**ADDENDUM NUMBER 3**

**PROJECT:** 46 KV Transmission Line – 2024 Modifications & Additions  
City of Fairhope (**BID NO. 25-003**)

**FROM:** Stewart Engineering, Inc.  
PO Box 2233  
Anniston, AL 36202  
(256) 237-0891

This addendum forms a part of the Contract Documents and modifies the original Construction Documents, Drawings and Specifications dated October, 2024 as noted below.

CITY OF FAIRHOPE	
46KV TRANSMISSION LINE - 2024	
MODIFICATIONS & ADDITIONS ALTERNATE #2	
DRAWN BY: ACG	DATE: 10-10-24
APPROVED BY: JLJ	DATE: 10-10-24
DWG#: AX23103-1	STEWART ENGINEERING ELECTRICAL CONSULTANTS ANNISTON, ALABAMA
SHEET: 14 OF 15	PHONE: (256)237-0891
SCALE: AS NOTED

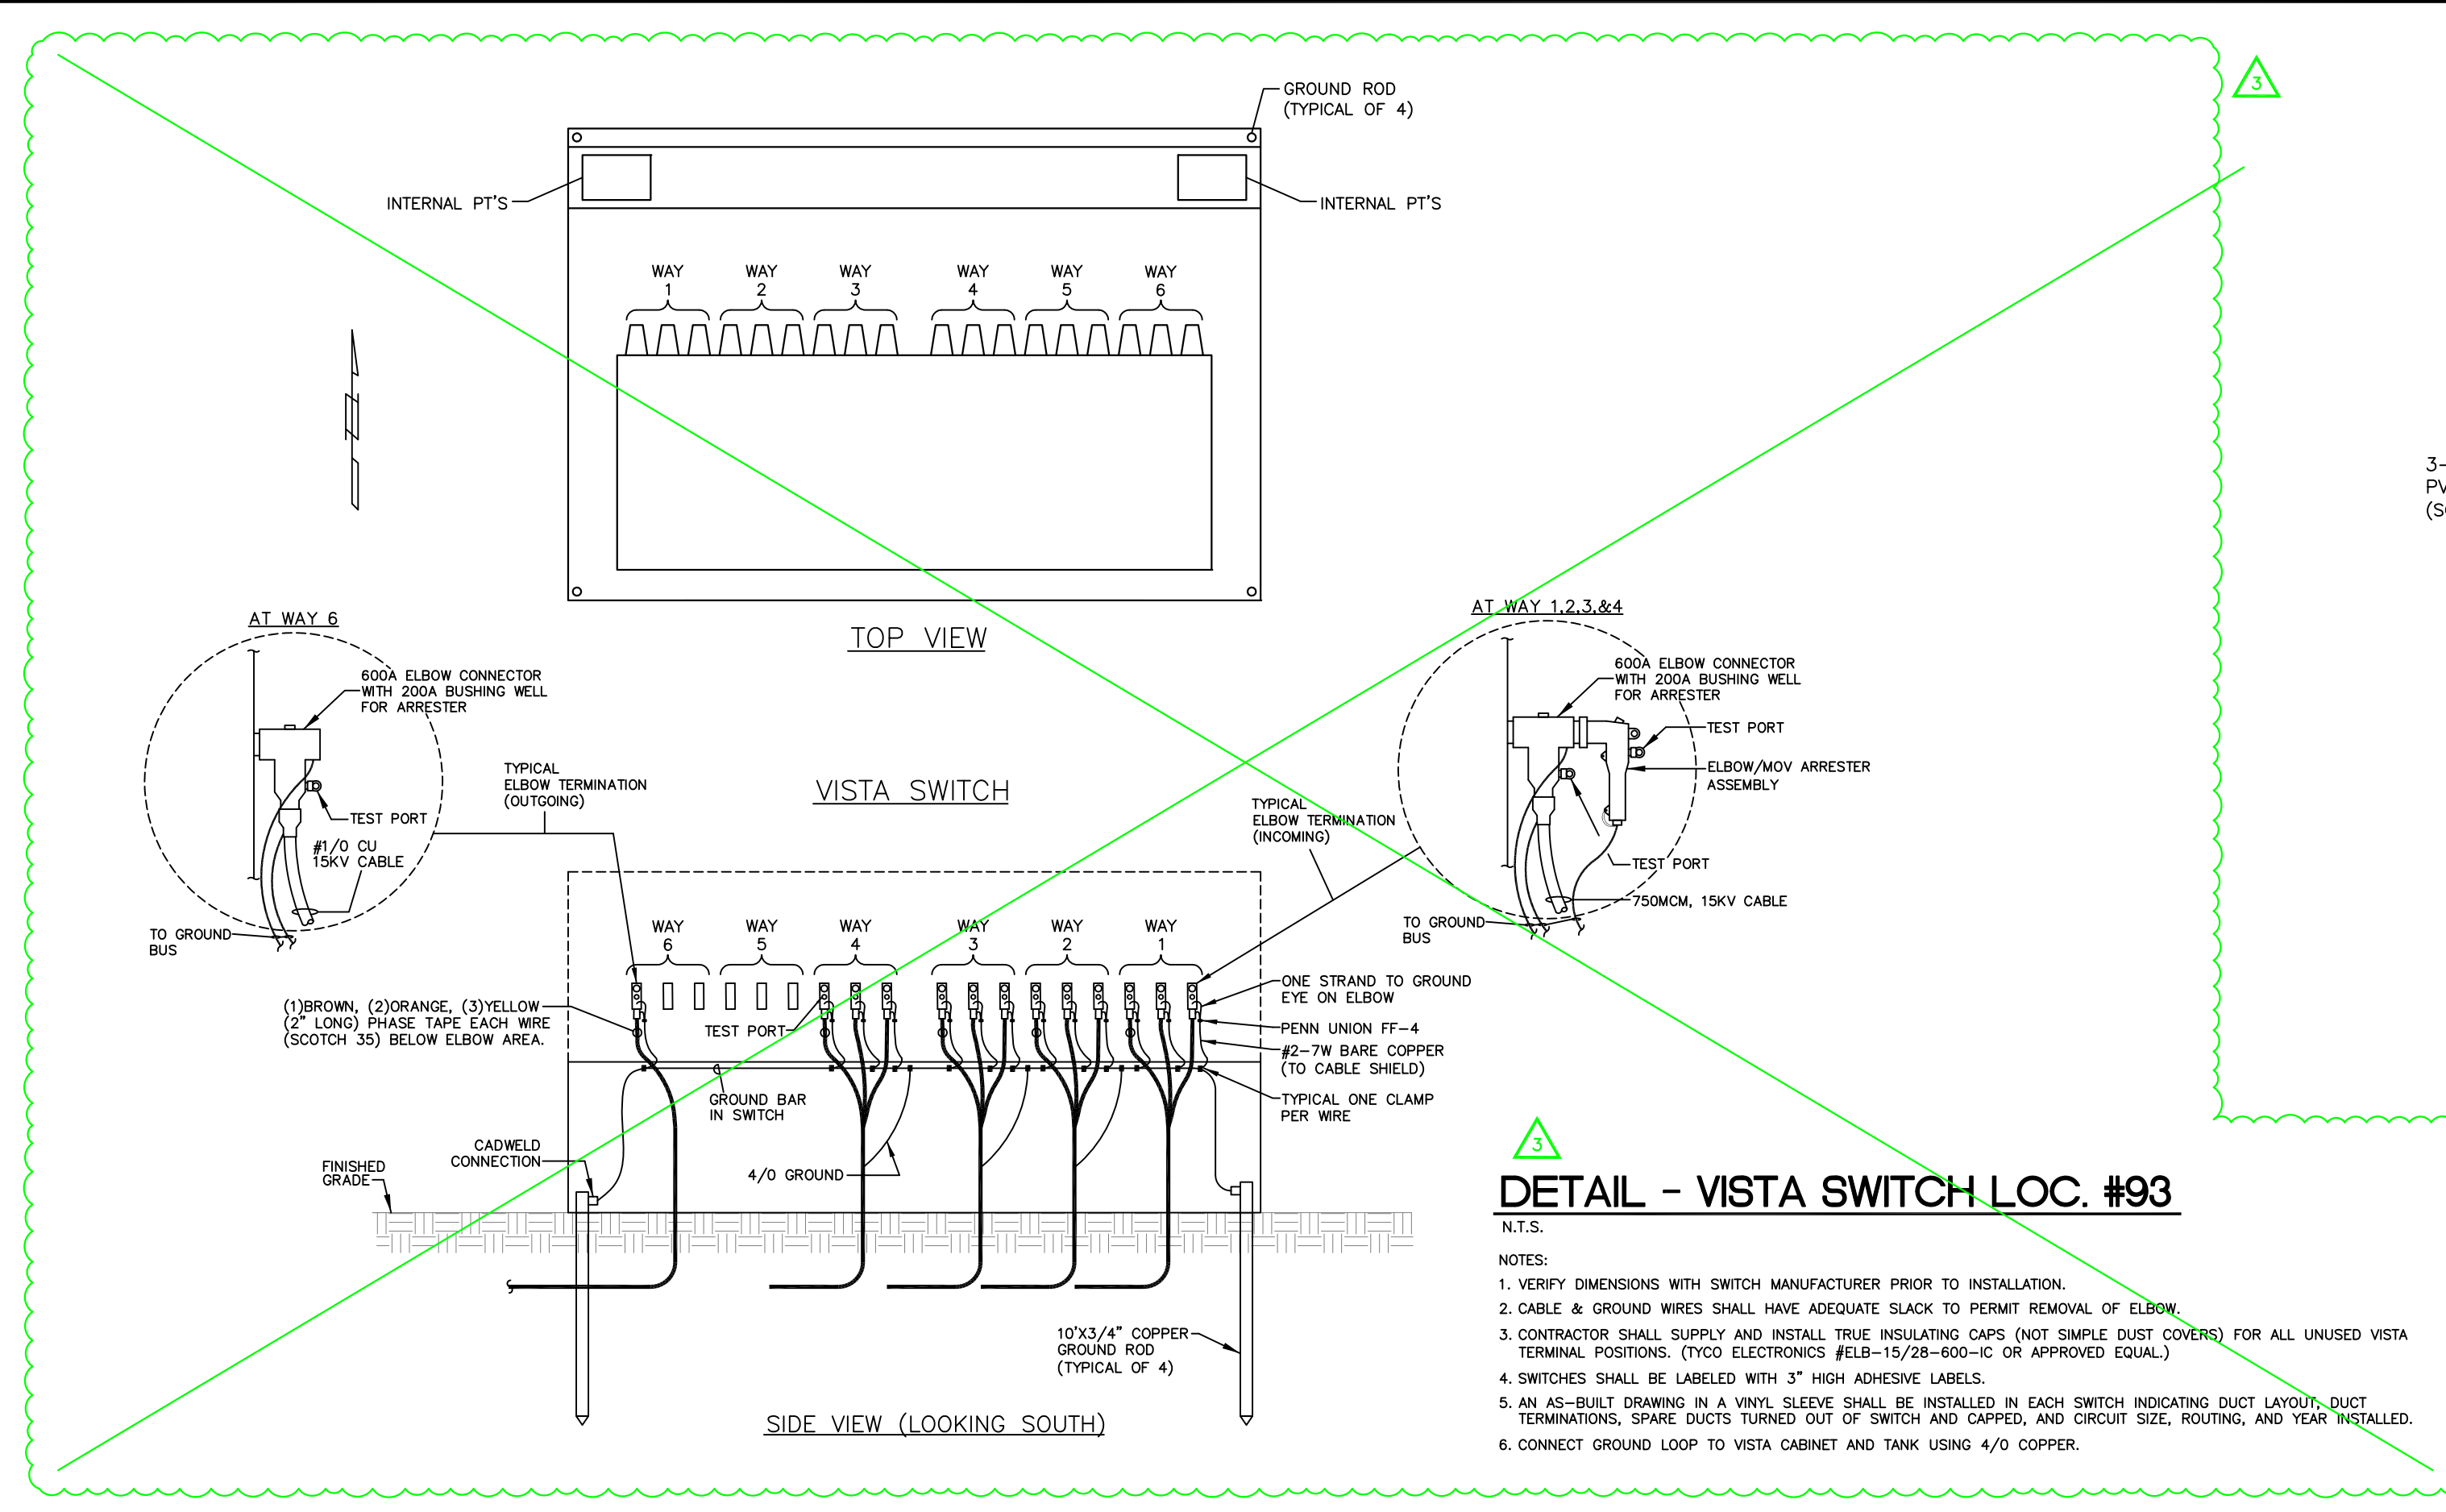
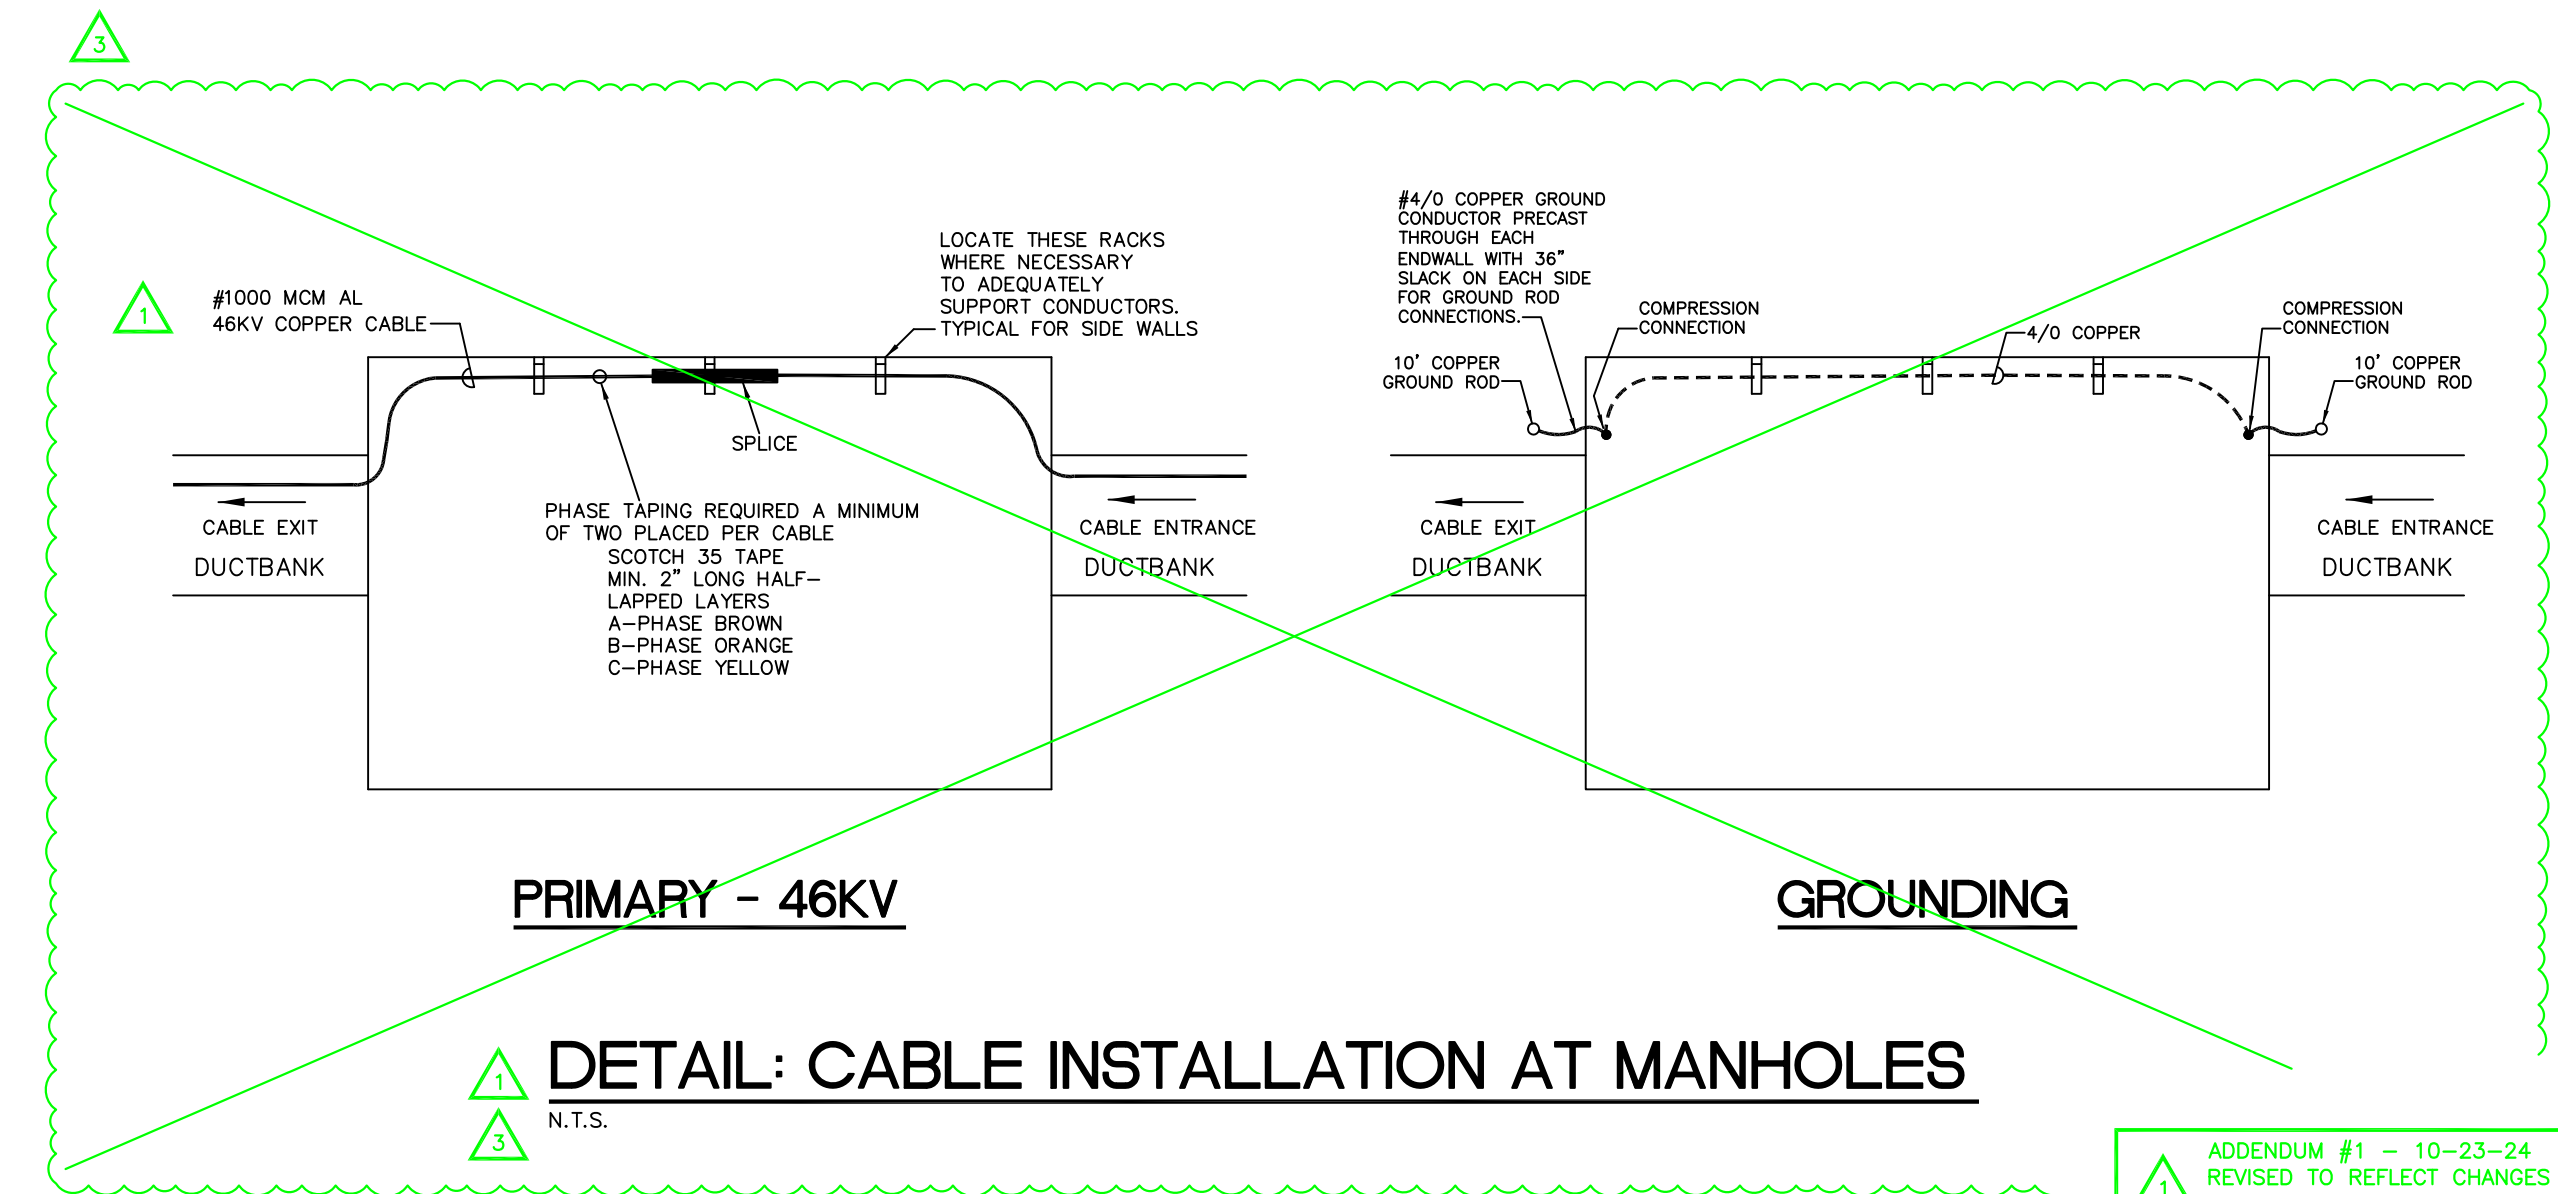
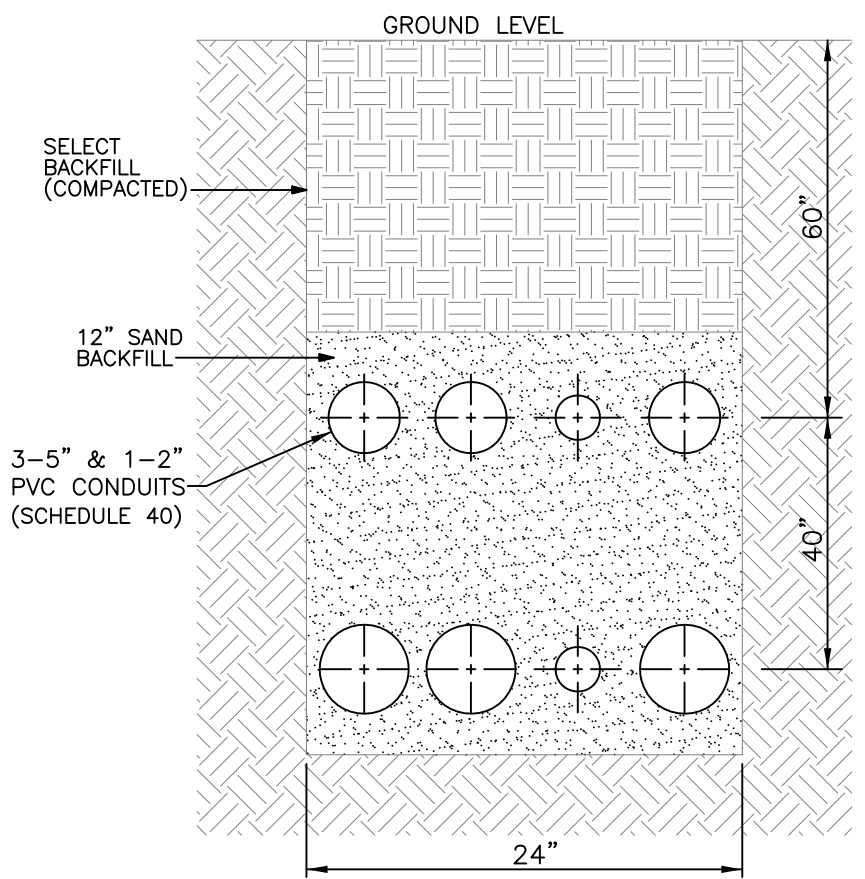
ADDENDUM #1 - 10-23-24  
REVISED TO REFLECT CHANGES ALONG MORPHY AVE. AND TO 46KV VAULTS.

ADDENDUM #3 - 11-4-24  
REVISED TO REFLECT CHANGES ALONG MORPHY AVE. AND TO REMOVE 46KV VAULTS.

- N.T.S.
- NOTES:
1. THE ABOVE DUCT BANK DETAILS ARE FOR NEW 46KV DUCT BANKS.
  2. DUCT BANK SHALL HAVE BACKFILL OF NOT MORE THAN 12" SAND.
  3. THIS CONTRACTOR SHALL PROVIDE A PROTECTIVE BARRIER BENEATH ANY EXISTING WATER PIPING. EXTEND 10' EITHER SIDE.
  4. THIS CONTRACTOR SHALL VERIFY ALL UTILITY DEPTHS PRIOR TO DUCT BANK CONSTRUCTION.
  5. CONTRACTOR SHALL SUPPLY AND INSTALL "DANGER TAPE" ABOVE ALL UNDERGROUND 46KV CABLE PIPES AT A DEPTH OF 8" BELOW FINAL GRADE.
  6. OWNER SHALL PROVIDE CONDUIT SPACERS. CONTRACTOR SHALL INSTALL SPACERS APPROXIMATELY EVERY 8'-10'.

CITY OF FAIRHOPE	
46KV TRANSMISSION LINE - 2024	
MODIFICATIONS & ADDITIONS ALTERNATE #2	
DRAWN BY: ACG	DATE: 10-10-24
APPROVED BY: JLJ	DATE: 10-10-24
DWG#: AX23103-1	STEWART ENGINEERING
SHEET: 15 OF 15	ELECTRICAL CONSULTANTS
SCALE: AS NOTED	ANNISTON, ALABAMA
	PHONE: (256)237-0891

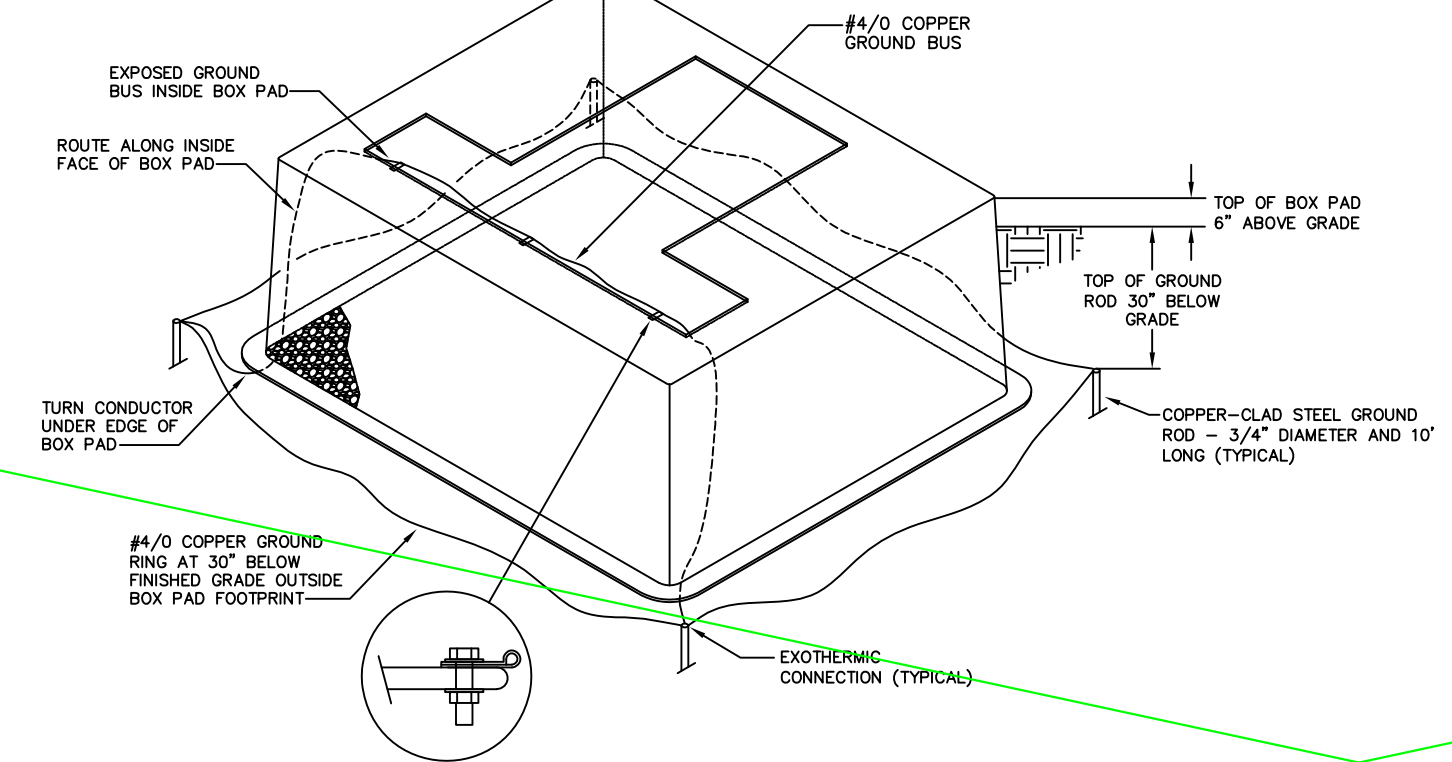
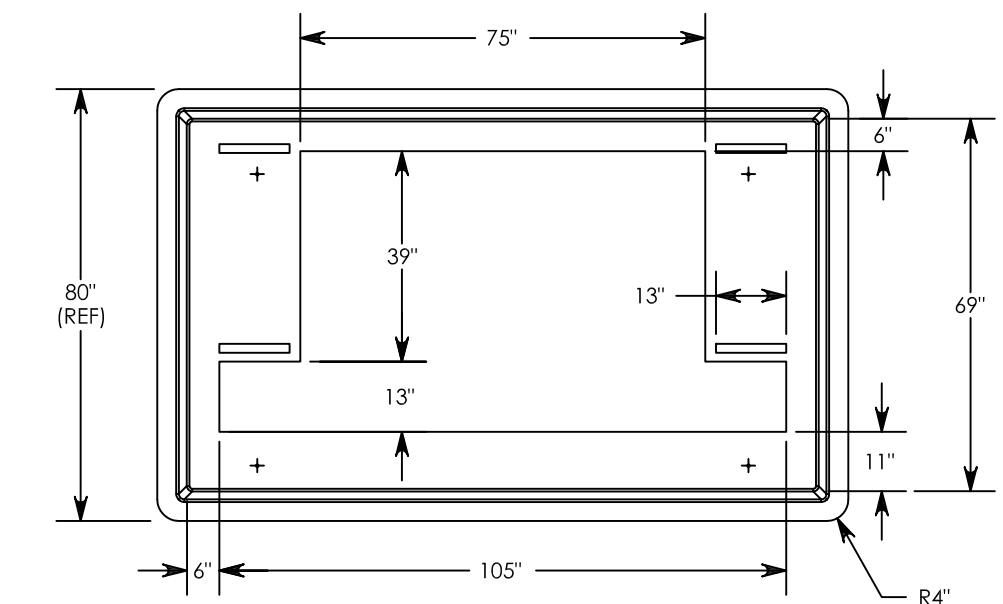
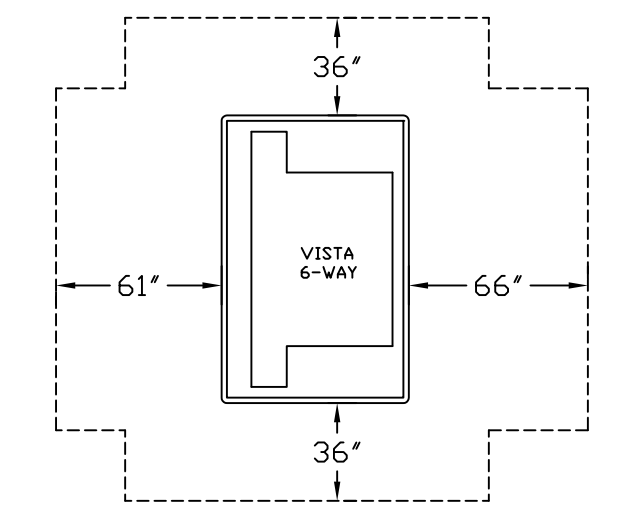
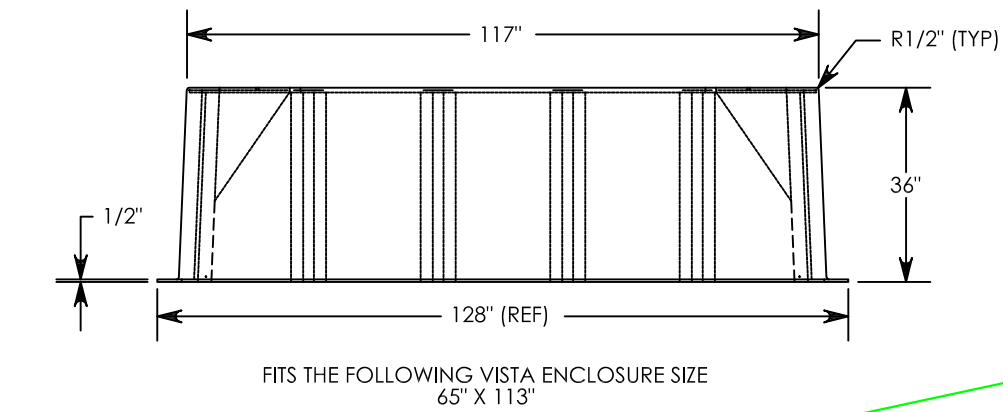
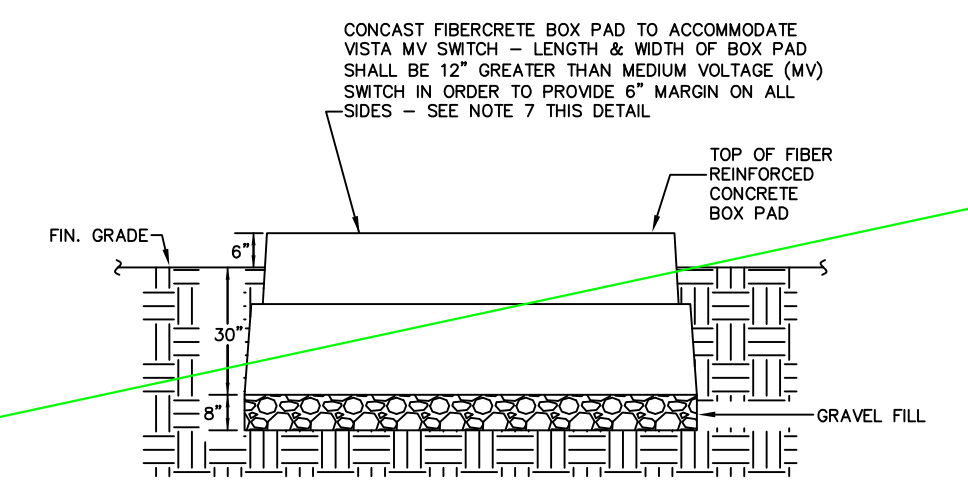
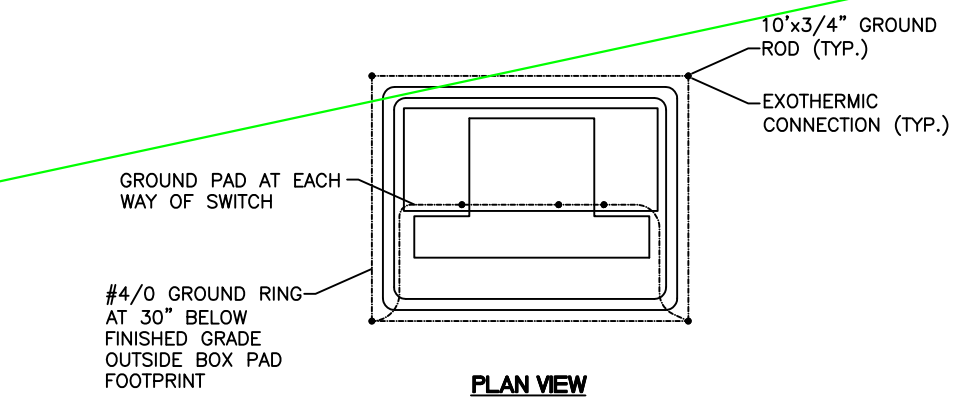
4. At ALDOT's request, the minimum requirement for the 20-inch encasement Bore Pipe under Greeno Road shall be HDPE STR 11.
5. All Conduits will be HDPE.
6. On Alternate No. 2, the Vista Switch has been REMOVED from the project. A S&C PME-9 Switch will be installed as shown on attached Drawings.
7. All 46KV Vaults on Alternate No. 2 have been REMOVED from the project. The 46KV Cable will be pulled with one continuous pull.

ADDENDUM #3 - 11-4-24  
REVISED TO REFLECT CHANGES  
ALONG MORPHY AVE. AND TO  
REMOVE 46KV VAULTS.
